# Access Compliance Report

## Public Rights-of-Way

### (Curb Ramps)

Intersection ID: 14035	Main Street: HANOVER_ST	Cross Street: SHENANDOAH_AV	Location: S
ADA ID: 6124EACD73BB	Ramp Type: Perp	Initial Pass/Fail: Fail	Overall Compliance: No
Severity Score: 22.5			
Codes/Mitigation Info/Possible Solution		Field Measurements/Component Compliance

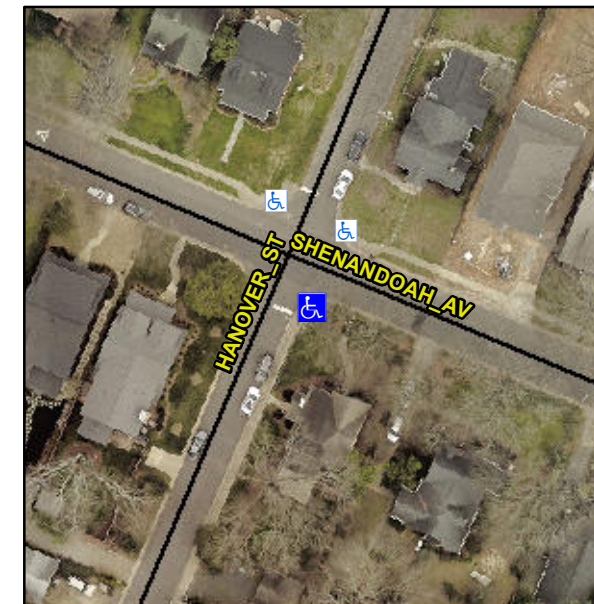
**Remove & Replace Entire Ramp.**

**R304.5.1, R304.2.2**

Compliance	Description	Data	Compliance	Description	Data
N/A	Ramp Length (in)	62.0	No	Ramp Slope (%)	10.8
No	Ramp Width (in)	43.0	Yes	Ramp XSlope (%)	2.5
N/A	Flare Type LT	N/A	N/A	Flare Type RT	N/A
N/A	Flare Slope LT (%)	N/A	N/A	Flare Slope RT (%)	N/A
N/A	Flare Traversable LT?	N/A	N/A	Flare Traversable RT?	N/A
N/A	Landing Length (in)	N/A	N/A	DWS Provided?	N/A
N/A	Landing Width (in)	N/A	N/A	DWS Contrast?	N/A
N/A	Landing Slope (%)	N/A	N/A	DWS Length (in)	N/A
N/A	Landing X Slope (%)	N/A	N/A	DWS Full Width?	N/A
N/A	Landing Curb? (Y/N)	N/A	N/A	DWS Offset (in)	N/A
N/A	Shared Landing?	N/A			
N/A	Gutter Ponding?	N/A	N/A	Gutter Slope (%)	N/A
N/A	Gutter Lip Ht (in)	2.0	N/A	Gutter X Slope (%)	N/A
N/A	Painted X Walk1?	No	N/A	Painted X Walk2?	N/A
	X Walk 1 Direction	To NE		X Walk 2 Direction	N/A
N/A	X Walk 1 Width (in)	N/A	N/A	X Walk 2 Width (in)	N/A
	X Walk 1 Slope (%)	2.2		X Walk 2 Slope (%)	N/A
	X Walk 1 X Slope (%)	2.8		X Walk 2 X Slope (%)	N/A
